SUBJECT: NORTH ANNA POWER STATION, UNIT NOS. 1 AND 2 – ISSUANCE OF AMENDMENTS TO REVISE TECHNICAL SPECIFICATIONS REGARDING NEW AND SPENT FUEL STORAGE (CAC NOS. MF9712 AND MF9713; EPID L-2017-LLA-0240)

Amendment No. 279
Renewed License No. NPF-4

Amendment No. 262
Renewed License No. NPF-7

SAFETY EVALUATION BY THE OFFICE OF NUCLEAR REACTOR REGULATION

Figure 3.7.18-1 (page 1 of 1)
Typical Region 1 Checkerboard

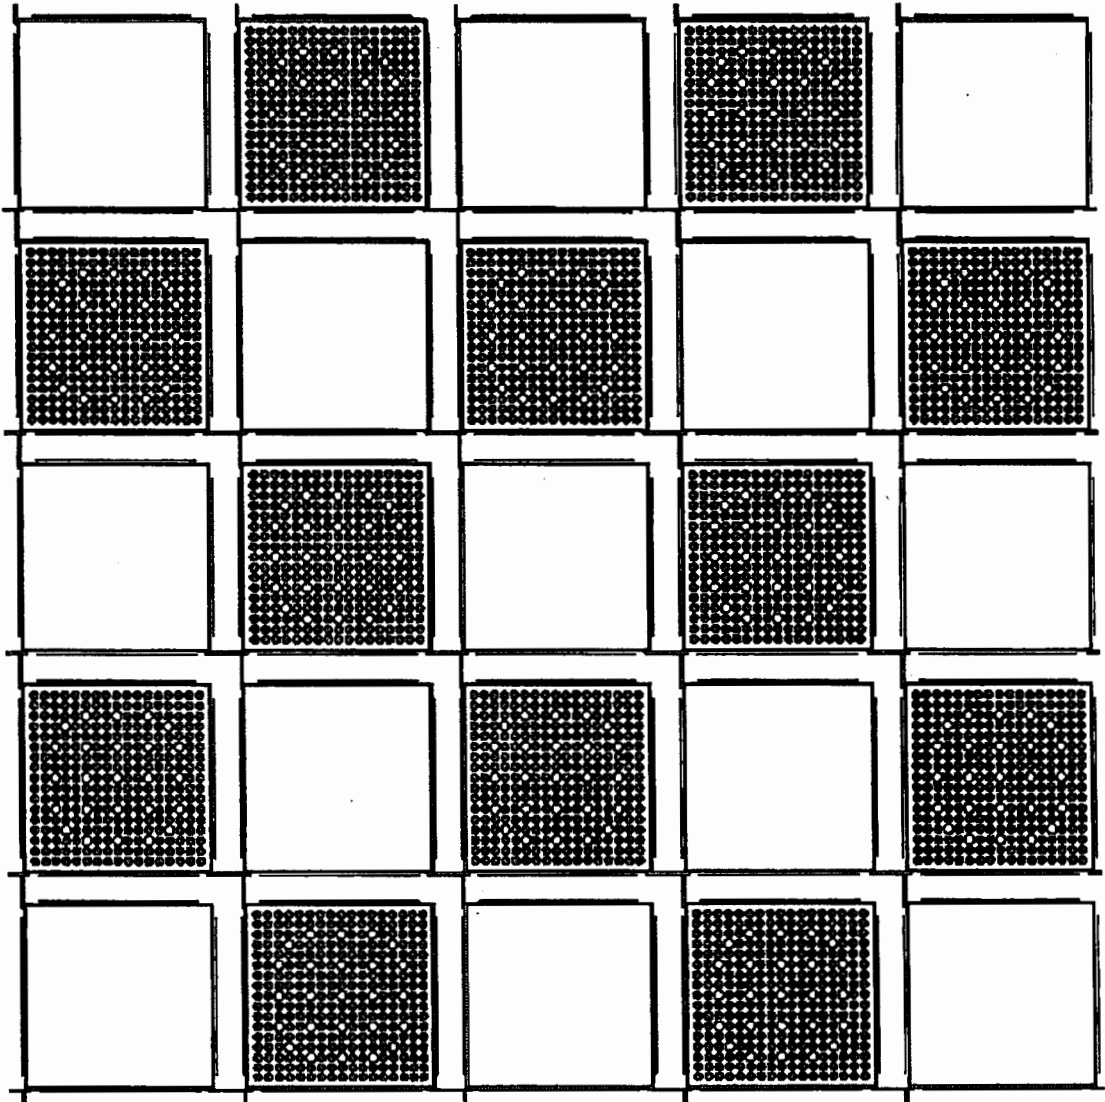
- I. Fuel assemblies stored in Region 1 shall be stored in a 2-out-of-4 checkerboard arrangement with empty cells per Figure 3.7.18-1:
 - i. Empty cells shall remain empty with the exception of a Rod Cluster Control Assembly (RCCA) and/or a cell blocker.
- II. A Region 1 checkerboard is a rectangle of assemblies that can be placed anywhere in the spent fuel pool with the following restrictions:
 - i. All 4 corners of a Region 1 block shall be an empty cell location.
 - ii. There shall be a minimum of two (2) Region 2 rows between two Region 1 blocks.
 - iii. Region 1 shall NOT cross a spent fuel rack module boundary.
 - iv. Spent Fuel Pool Locations AA21, AA22, BB21, BB22, CC21, and CC22 shall NOT be contained in a Region 1 block.
- III. There are no restrictions on burnup and cooling time on fuel of initial enrichment of less than or equal to 5.0 weight percent (wt%) U-235

- New Region 1 would require that fuel assemblies be stored in a new checkerboard arrangement (2-out-of-4 storage), but would have no burnup curve. The new Region 1 requirements take credit for the neutron leakage when next to the SFP wall. There would be restrictions relative to the Region 1/Region 2 interface.

Figure 3.7.18-2 (page 1 of 1)
Minimum Burnup Requirements for Region 2 With No Credit for Cooling

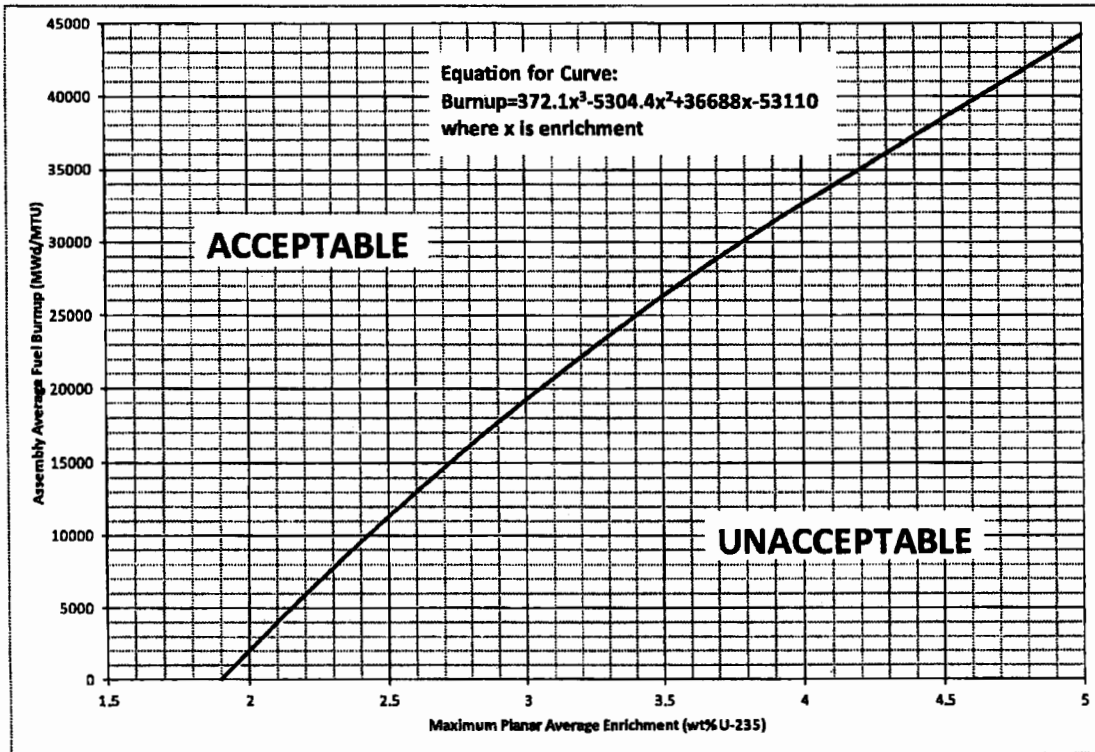
- I. Irradiated fuel assemblies with a combination of initial enrichment and burnup in the "Acceptable" burnup domain in Figure 3.7.18-2 may be stored in Region 2.
- II. Irradiated fuel assemblies cooled three (3) or more years with a combination of initial enrichment and burnup in the "Acceptable" burnup domain in Figure 3.7.18-3 may be stored in Region 2.

- New Region 2 would have two new burnup curves and all Region 2 storage locations would be available for fuel assembly storage. One of the new burnup curves would also incorporate assembly cooling time for determining whether a fuel assembly is permitted to be stored in Region 2. The storage of any fuel assembly containing a full length RCCA would be permitted in Region 2 without regard to the new burnup curves.
